**PLANNED UNIT DEVELOPMENT
& SUBDIVISION STAFF REPORT****Date: April 5, 2018****DEVELOPMENT NAME**

Saunders Subdivision, Resubdivision of Lot 1

LOCATION840 Dumaine Road
(Southeast corner of Dumaine Road and Conception Street Road).**CITY COUNCIL
DISTRICT**

CONTEMPLATED USEPlanned Unit Development to amend a previously approved
Planned Unit Development to allow multiple buildings on a
single building site.**TIME SCHEDULE
FOR DEVELOPMENT**

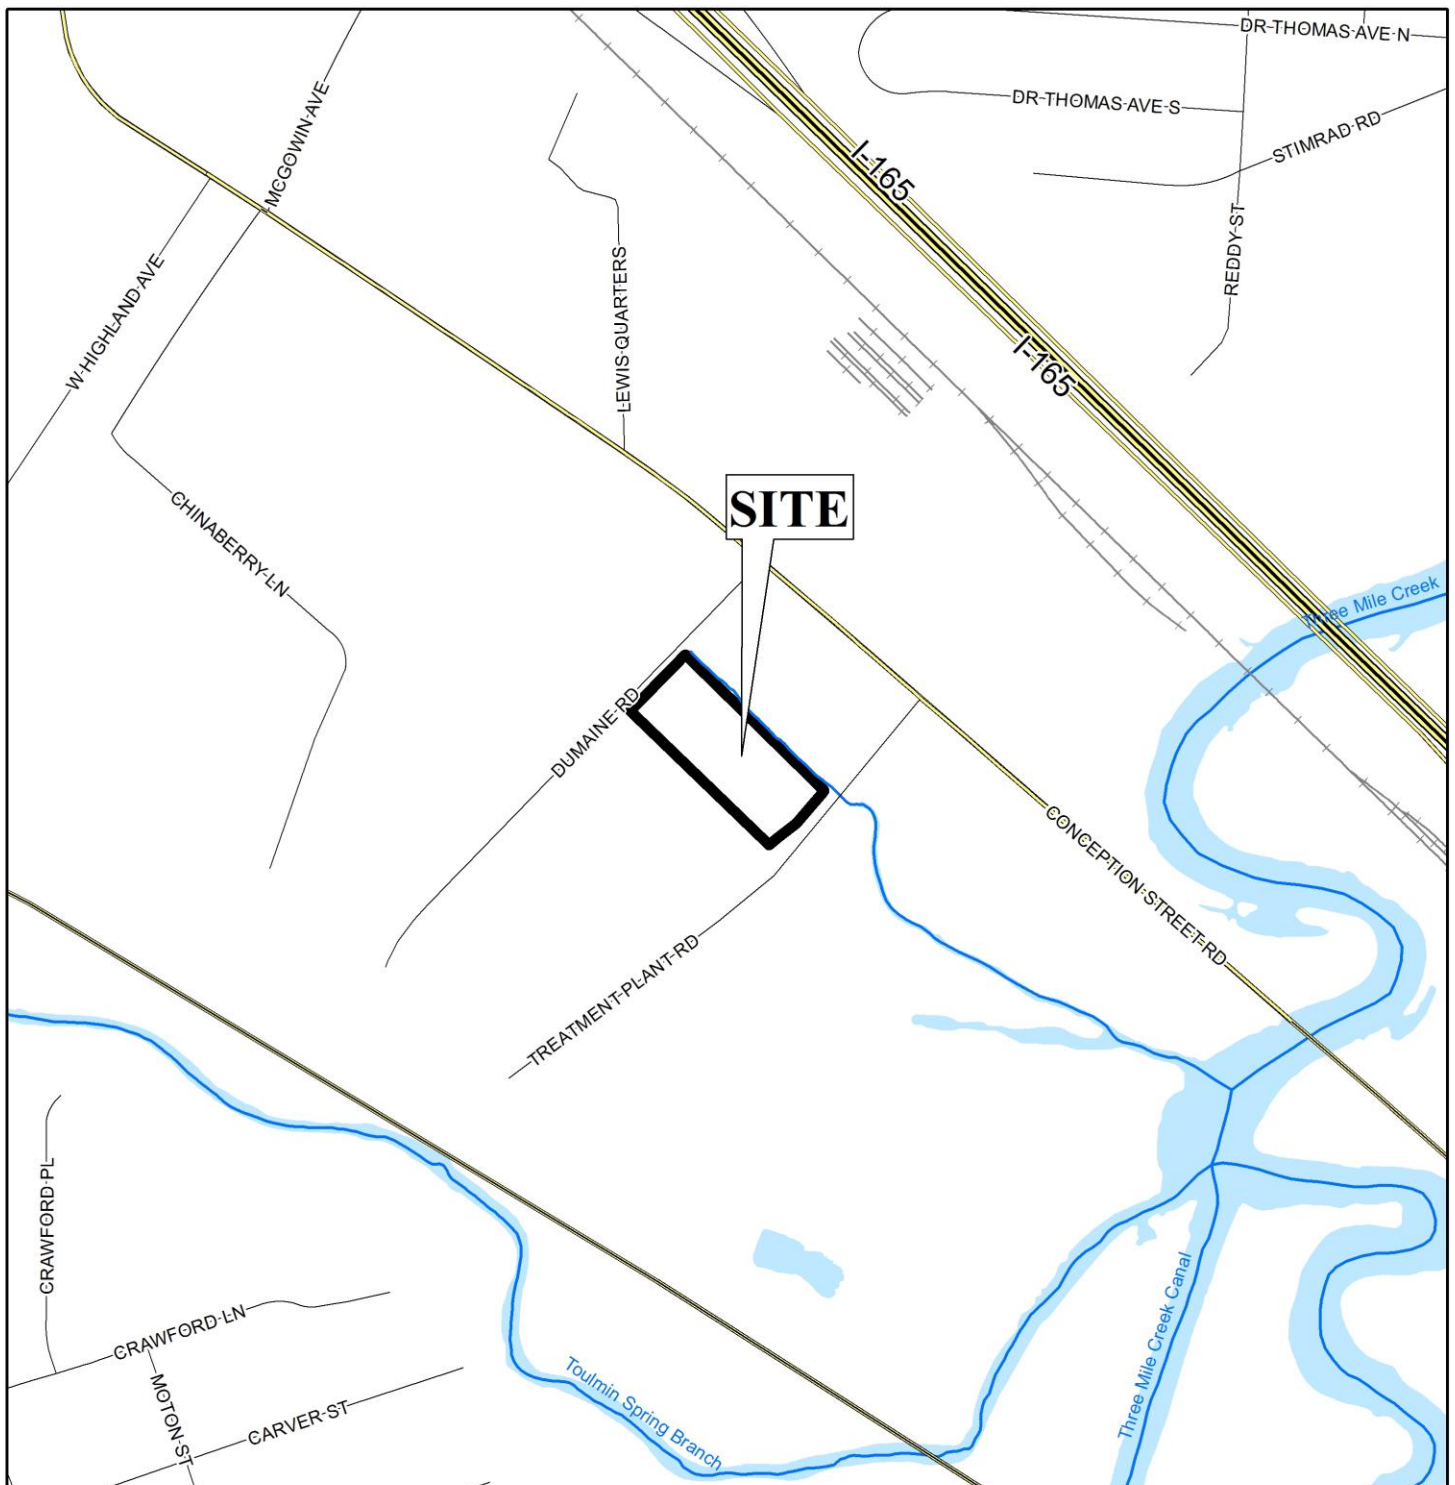
**ENGINEERING
COMMENTS**Drawing submitted does not indicate the limits of the
proposed PUD on the drawing. Also, the notes, etc.
indicate that it is a Plat drawing.**ADD THE FOLLOWING NOTES TO THE PUD SITE PLAN:**

The site is within an I-1, Light Industry District, and is developed with what appears to be six (6) buildings, though a previous site plan indicates two (2) of these are metal canopies. Two (2) additional areas are identified as “Building Floors,” but are not identified as actual buildings. Aerial photos do seem to indicate these “Building Floors” are actual structures whose sizes are $825\pm$ square-feet, when combined, exclusive of any other structure to which they may be attached. The aggregate size of all *known* structures on the site is $24,123\pm$ square-feet, $8,080\pm$ square-feet of which is identified as office space, and $11,639\pm$ square-feet is identified as warehouse and storage-type spaces. The uses of the remaining $5,219\pm$ square-feet of building space, to include the “Building Floor” areas, are unknown. If approved, revision of the site plan to indicate each building and its current or proposed use should be required.

The site plan illustrates 23 off-street, paved parking spaces, two (2) of which appear to be van accessible, and all of which appear to comply with stall length and width requirements. Also illustrated are approximately 50 wheel stops surfaced with aggregate material, an acceptable surfacing material in I-1, Light Industry Districts. The applicant proposes to stripe and provide wheel stops for an additional seven (7) paved parking spaces, which also appear would comply with parking stall length and width requirements.

Staff cannot determine the required amount of off-street parking requirements since no calculations were provided by the applicant regarding the number of warehouse employees, or the uses of the additional building spaces, though at least 27 parking spaces are required for the $8,090\pm$ square-feet of office area. As such, additional parking may be required; however, it should be noted that the site has remained substantially unchanged for 30 years, with the exception of the work approved by the previous Approvals, thus existing parking ratios may be considered non-conforming. Nevertheless, any future expansion of the offices, warehouse(s), or other enclosed spaces on the site will require an adequate number of parking spaces be provided in compliance with the Zoning Ordinance.

A dumpster is not depicted on the site plan and one is not clearly visible in recent aerial photos. Any dumpster placed on the property must be in compliance with the current enclosure and sanitary sewer connection requirements of Section 64-4.D.9. of the Zoning Ordinance and must be illustrated on any revised site plan(s); or, placement of a note should be provided on a revised site plan stating that curbside pickup will be utilized, if approved.

The 25' minimum building setback line is illustrated along Dumaine Road, but not along Treatment Plant Road. The site plan should be revised to illustrate the 25' minimum building setback line along Treatment Plant Road.

Per Traffic Engineering's review of the aforementioned Subdivision, a note should be placed on the site plan stating the lot on which the PUD site is developed is limited to two (2) curb cuts to Dumaine Road, and that access to Treatment Plant Road is denied; and, that any changes to the sizes, locations or designs of all curb cuts are to be approved by Traffic Engineering and conform to AASHTO standards.

One (1) easement is illustrated on the site plan that was not addressed by staff in the Subdivision request: a 10' permanent easement between the two (2) proposed lots. As such, a note should be placed on the site plan stating no structures shall be constructed in any easement.

It should be noted that the site plan provided includes the adjacent lot, "Lot 1," from which it is proposed to be subdivided. The proposed lot, as mentioned, is no longer to be included as part of the PUD site. As such, revision of the site plan to only illustrate the lot, "Lot 2," on which the remainder of the PUD site is to be maintained should be required, if approved.

- 1) revision of the site plan to identify each building and its current or proposed use;
- 2) revision of the site plan to illustrate a dumpster in compliance with the enclosure and sanitary sewer connection requirements of section 64-4.D.9. of the Zoning Ordinance, or placement of a note on the site plan stating curbside pickup will be utilized;

- 3) retention of the lot sizes on which the PUD site is developed in square feet and acres;
- 4) revision of the site plan to illustrate the 25' minimum building setback line along all street frontages;

- 5) placement of a note on the site plan stating the site is limited to two (2) curb cuts to Dumaine Road, that access is denied access to Treatment Plant Road, and that any changes to the sizes, locations or designs of all curb cuts are to be approved by Traffic Engineering and conform to AASHTO standards;

- 6) placement of a note on the site plan stating no structures shall be constructed in any easement;
- 7) revision of the site plan to remove the proposed Lot 1 from the PUD;
